**Pond vs Peninsula**

To: Mr. Ron Purkey, P.E. – TVA  
From: Neil Davies and Bob Bachus – GeoSyntec  
Date: 4 February 2005  
Subject: **Bottom Drainage Layer Alternatives, Proposed Dredge Cell Lateral Expansion, Kinston Fossil Plant**

# **Position Paper on the Whether the Drainage Blankets Can be Removed from TVA's Pending Solid Waste Disposal Applications for Bull Run and Kingston Fossil Plants**

**Figure 2**  
**Schematic Diagram Showing the Layout of the Proposed Bottom Drainage Layer (Case 2)**

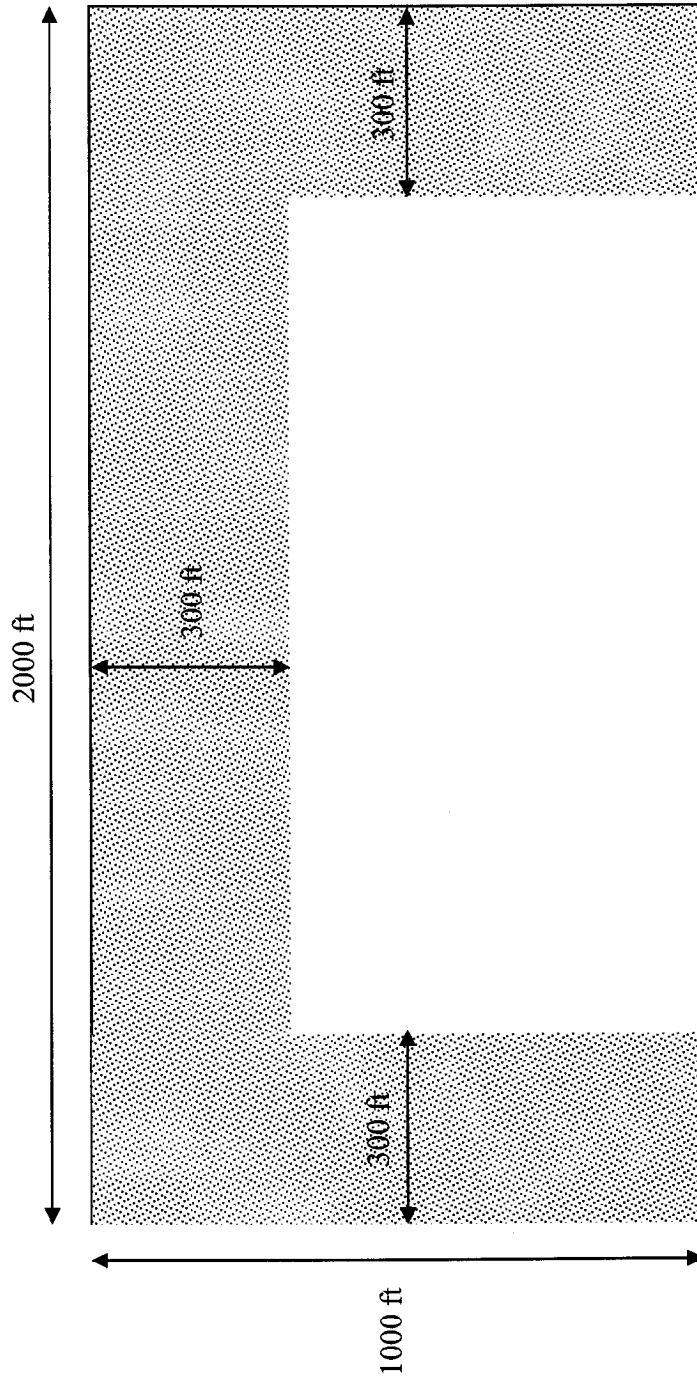
In Case 2, we modeled the effect of a highly permeable drainage blanket that would extend 300 feet inwards from the toe of the slope on three sides (Figure 2). As in Case 1, the material was assumed to be saturated at year 0. Using the dimensions indicated, the area of the drainage blanket used in Case 2 is approximately 50 percent of the total footprint of the base. Figure 3 indicates that under this configuration, a 300-foot wide base drain located around the perimeter is very effective at lowering the phreatic surface

within 200 feet of the face of the slopes. The rate that the water level lowers at the edges is comparable to the rate for the complete bottom drainage layer shown in Figure 1. The phreatic surface within the interior of the fill is lowered to an elevation within the lower third of the height within a ten to fifteen year period. While this is slower dissipation than the full coverage drain, the partial drainage blanket is shown to be effective at lowering the level within the entire impoundment. If the blanket drain is extended further towards the center of the fill, the phreatic surface moves farther from the face of the slope and the rate at which the phreatic surface is lowered within the interior of the fill increases. The actual design extent of the partial drain would be determined during the final design, but this simple model demonstrates that a partial blanket drain can be highly effective at lowering the phreatic surface, while providing significant potential cost savings..

**Figure 2**  
**Schematic Diagram Showing the Layout of the Proposed Bottom Drainage Layer (Case 2)**

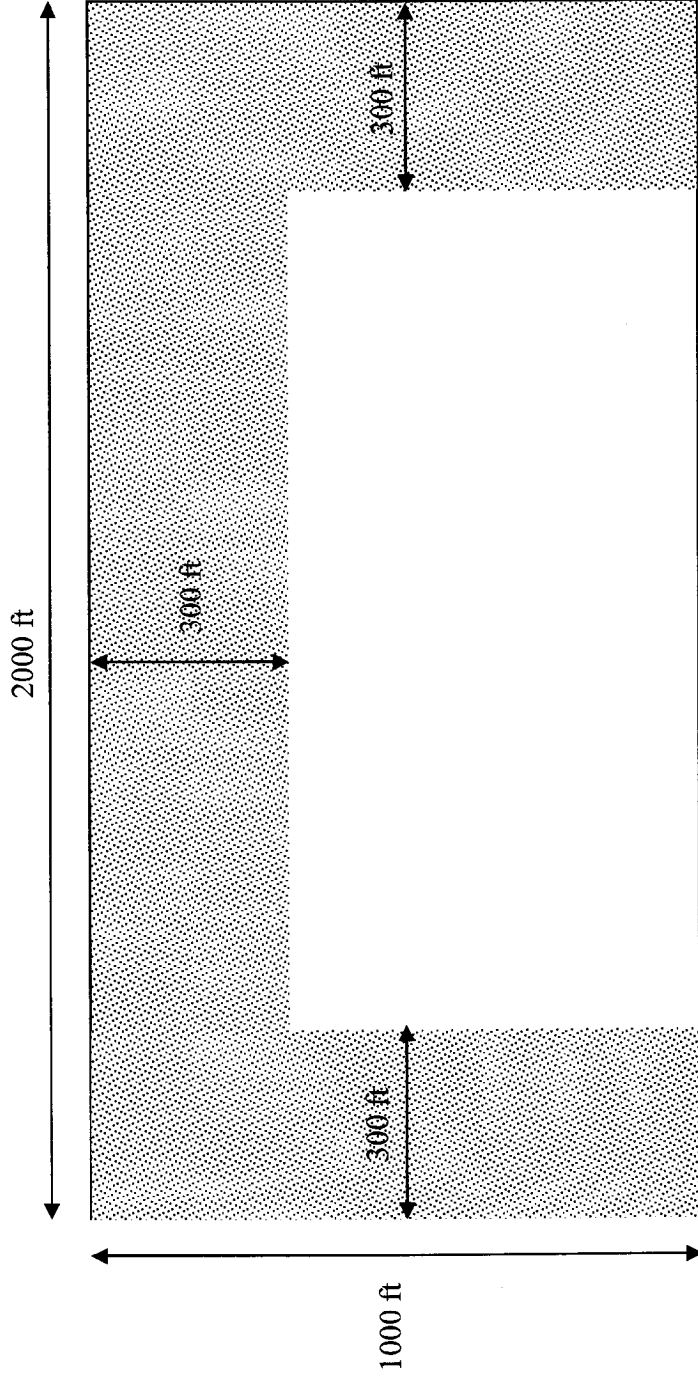
In Case 2, we modeled the effect of a highly permeable drainage blanket that would extend 300 feet inwards from the toe of the slope on three sides (Figure 2). As in Case 1, the material was assumed to be saturated at year 0. Using the dimensions indicated, the area of the drainage blanket used in Case 2 is approximately 50 percent of the total footprint of the base. Figure 3 indicates that under this configuration, a 300-foot wide base drain located around the perimeter is very effective at lowering the phreatic surface

within 200 feet of the face of the slopes. The rate that the water level lowers at the edges is comparable to the rate for the complete bottom drainage layer shown in Figure 1. The phreatic surface within the interior of the fill is lowered to an elevation within the lower third of the height within a ten to fifteen year period. While this is slower dissipation than the full coverage drain, the partial drainage blanket is shown to be effective at lowering the level within the entire impoundment. If the blanket drain is extended further towards the center of the fill, the phreatic surface moves farther from the face of the slope and the rate at which the phreatic surface is lowered within the interior of the fill increases. The actual design extent of the partial drain would be determined during the final design, but this simple model demonstrates that a partial blanket drain can be highly effective at lowering the phreatic surface, while providing significant potential cost savings..
